What we heard report

Stage 1 public consultation: Draft Billabong Creek Floodplain Management Plan

March 2025

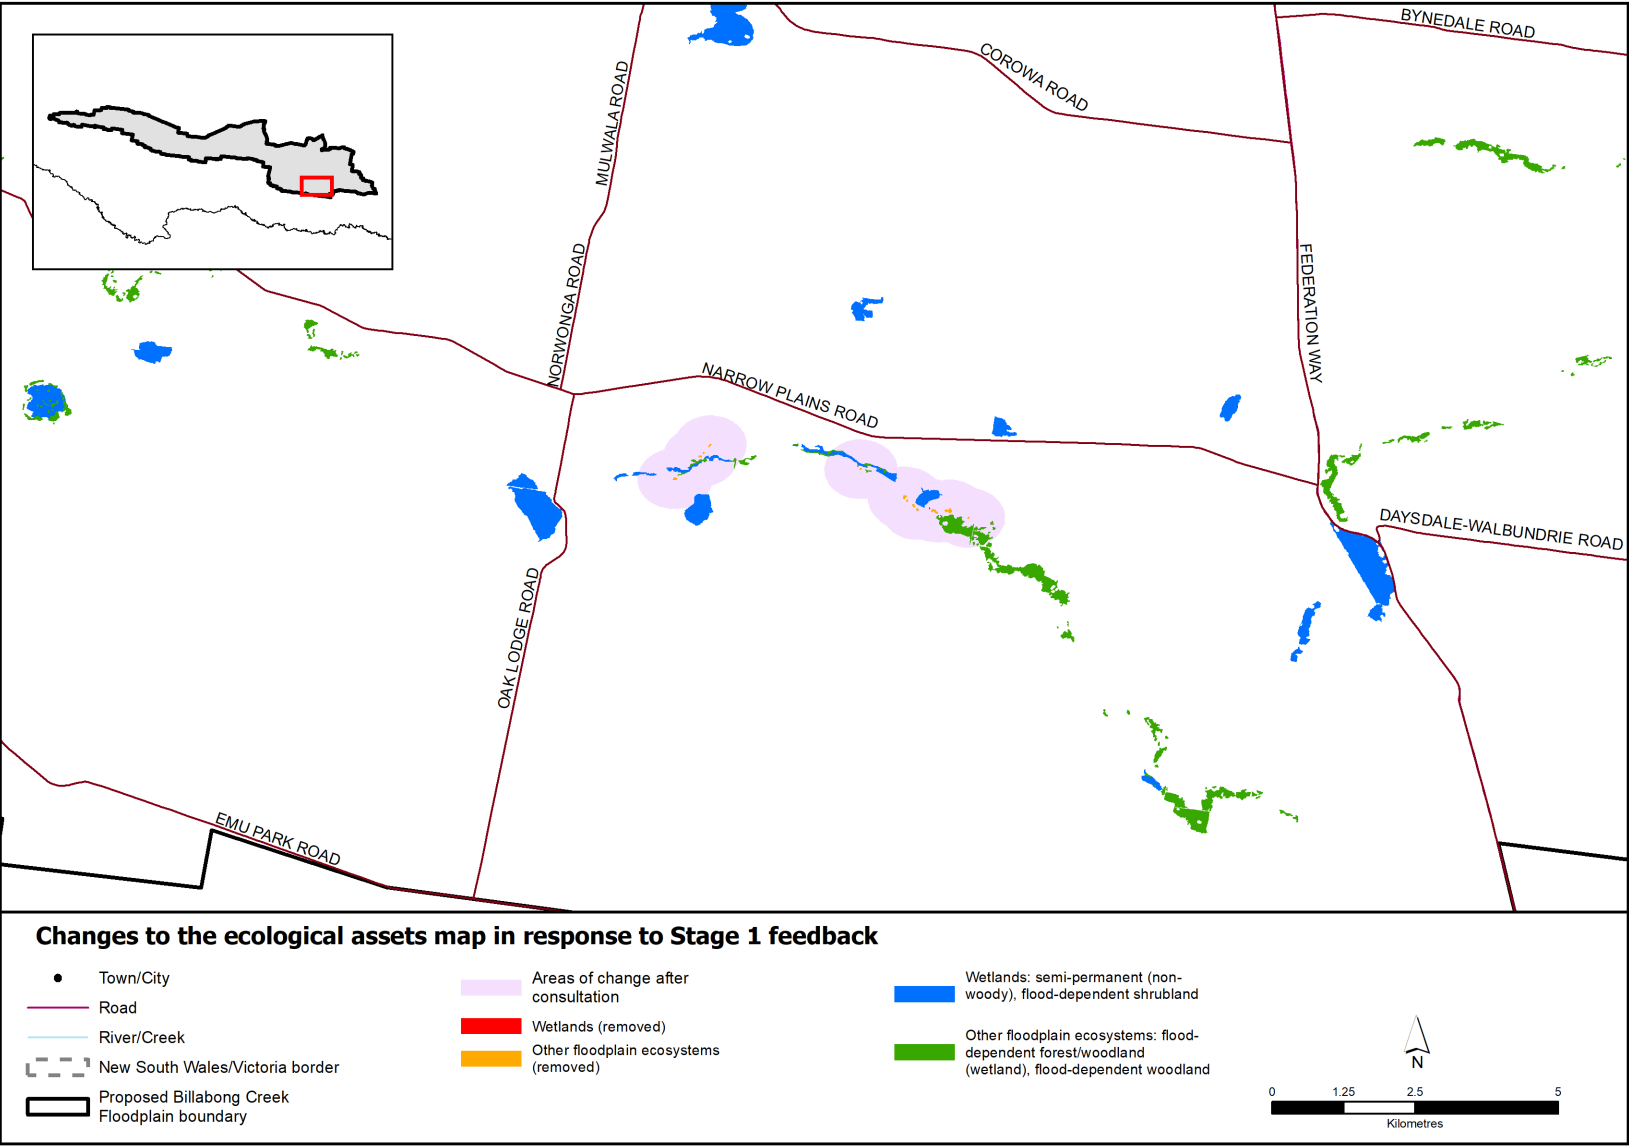
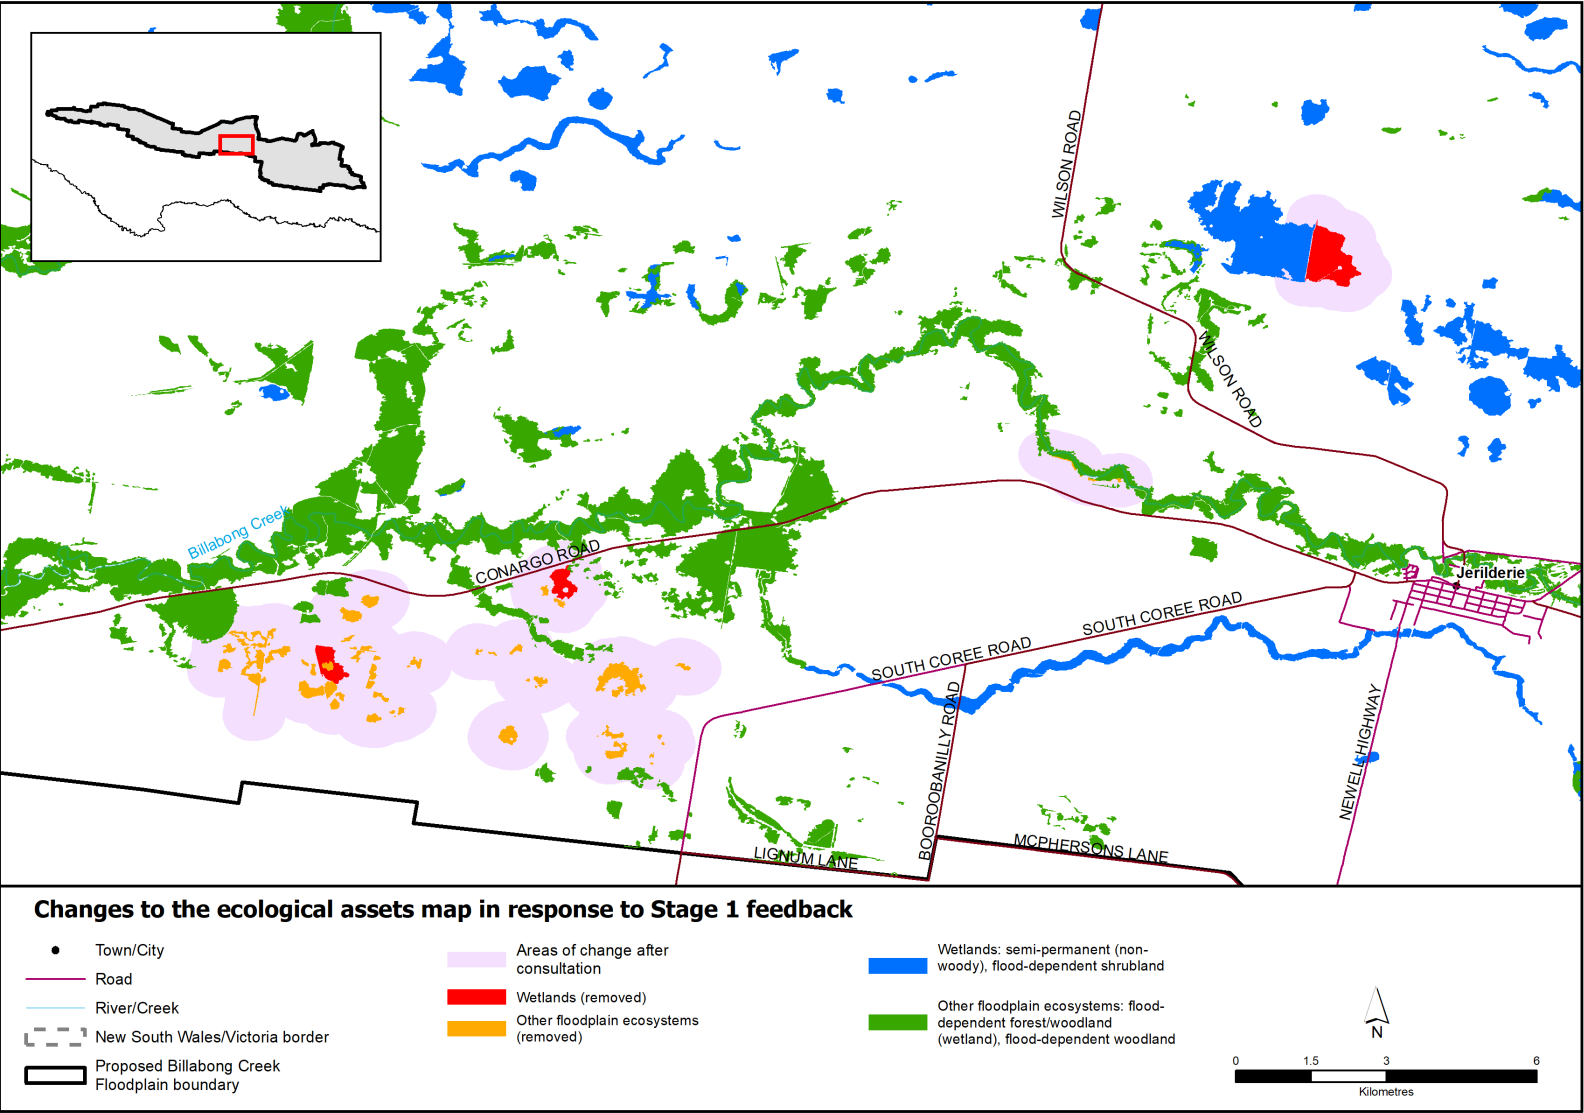
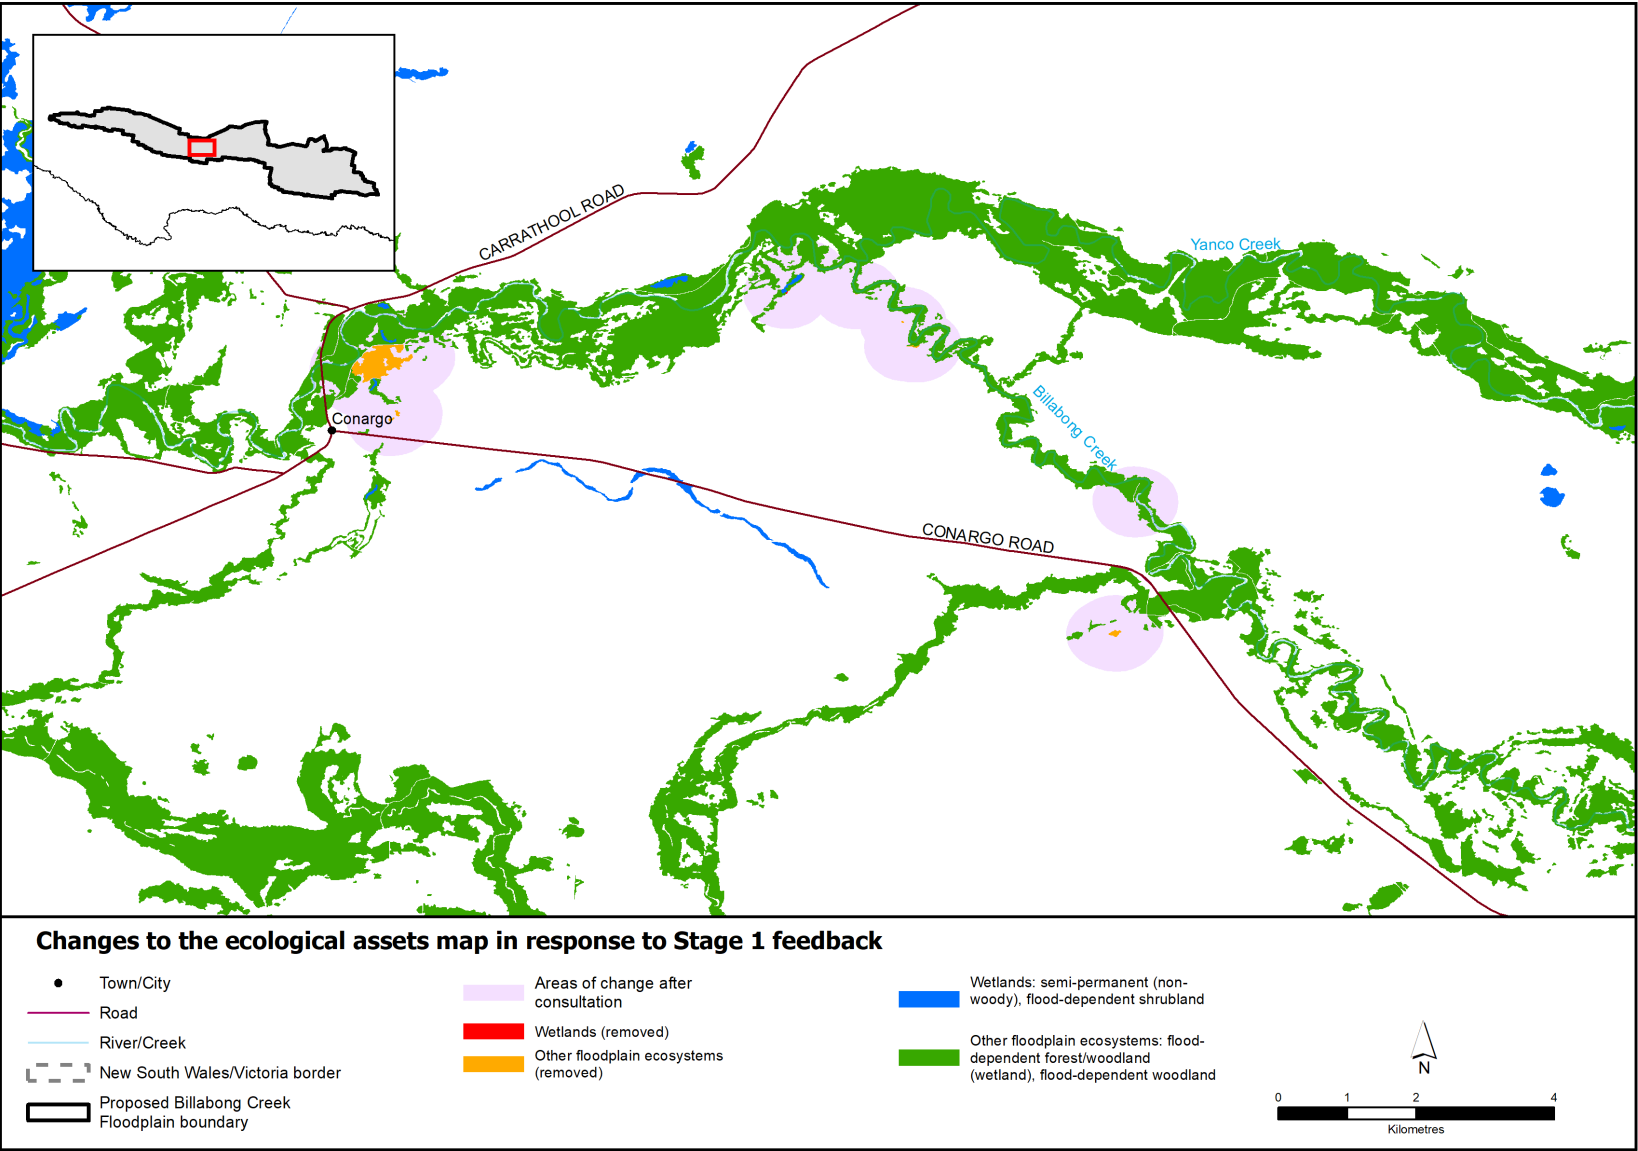
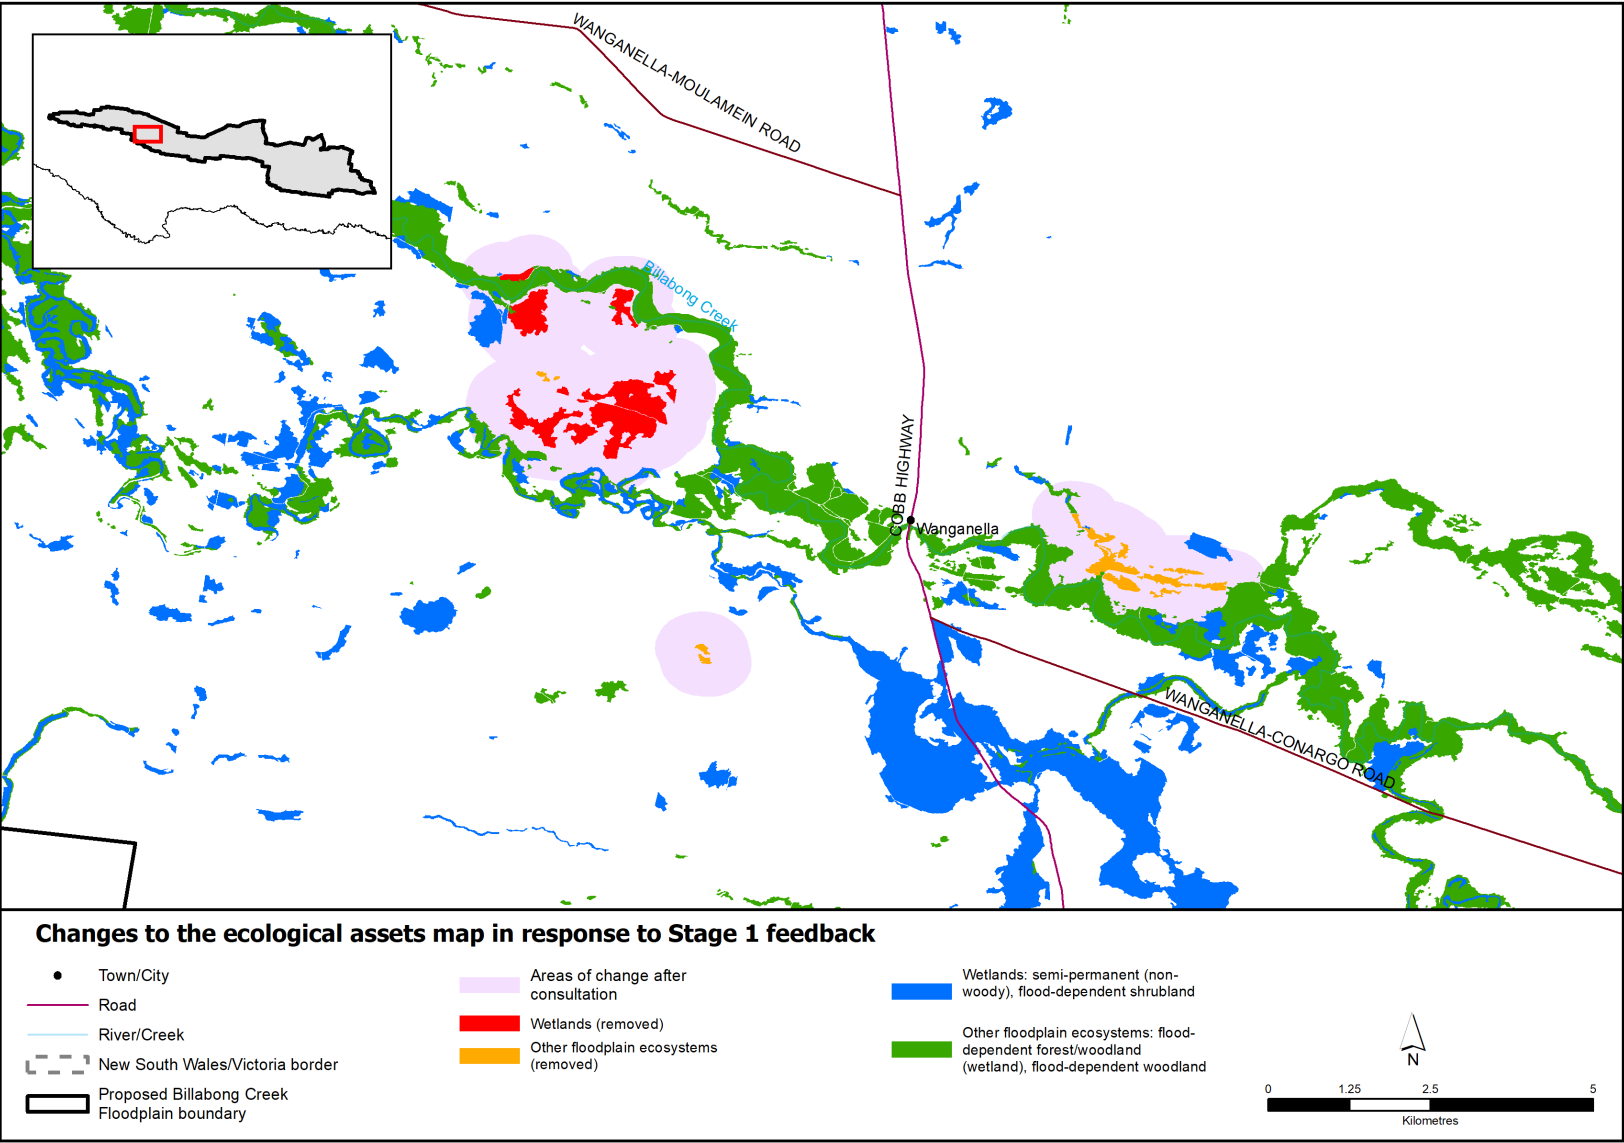
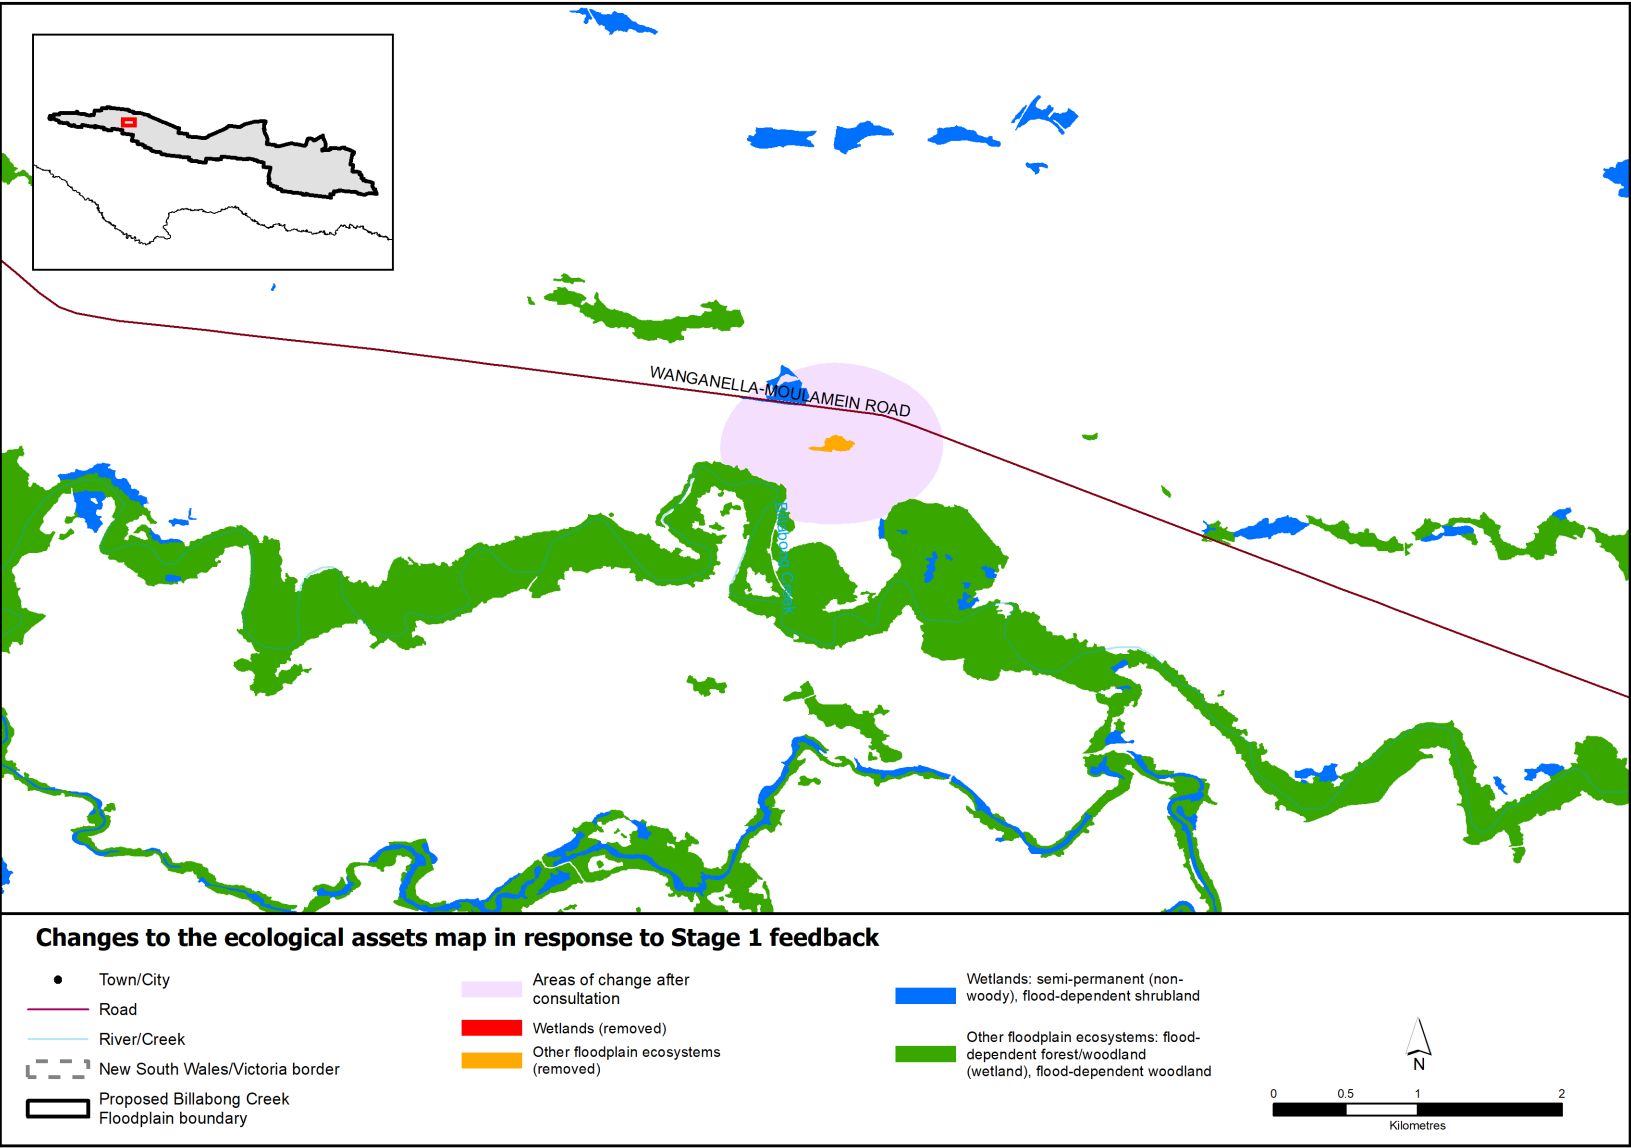
Feedback	Departmental response
Ecological assets generally look correct at a property scale.	Noted.
Some ecological assets are no longer visible and should not be considered flood-dependent ecological assets. For example, mapped areas of native vegetation in developed or cultivated areas, isolated paddock trees that are watered by local rainfall. Localised, property-scale feedback on the mapped ecological assets was provided via a map.	The feedback received has resulted in multiple refinements being made to the identified ecological assets in multiple areas. These refinements are shown in Appendix 4 and include the removal of: • ecological assets that are no longer visible within developed or cultivated areas • isolated trees in areas that have previously been cleared • gardens associated with dwellings and outbuildings. An updated interactive spatial map will be published as part of Stage 2 public exhibition of the draft FMP.

The plant community type of some of the identified ecological assets have been categorised incorrectly. For example, Red Gum Forest is actually Black Box woodland or floodplain wetland is actually Old Man Saltbush country.	Noted. Both River Red Gum and Black Box plant community types are categorised as flood-dependent ecosystems for the purposes of the draft FMP. An updated interactive spatial map will be published as part of Stage 2 public exhibition of the draft FMP.
It looks like a desktop review rather than any ground truthing.	A variety of wetland mapping and information sources have been used to identify the flood-dependent ecological assets. The department is limited in conducting on ground field surveys at the scale required for whole-of-valley FMPs. Often wetlands and other floodplain ecosystems have also changed through time and can be incorrectly identified. These issues

Feedback	Departmental response
	While some wetlands or habitat for flood-dependent fauna has been degraded, these areas can still serve an important ecological function in the floodplain and require protection from future changes in flood behaviour.
The ecological assets marked in yellow on the map appear to represent the ecological areas supported by inundation. We don't agree with this approach – the inundated area should not be the default ecological asset area.	Noted. The identified flood-dependent ecological assets will often align with the proposed floodways and inundation extent. This is because the approach typically involves areas identifying flood-dependent vegetation which requires some degree of inundation to maintain its ecological viability. The draft FMP will distinguish between ecological assets outside the floodway network and ecological assets within the floodway network. Areas that have no flood-dependent vegetation or other ecological significance (for example, developed land) are generally excluded from the ecological asset layer. In response to feedback received refinements have been made to the identified ecological asset mapping in multiple areas. These refinements are shown in Appendix 4.
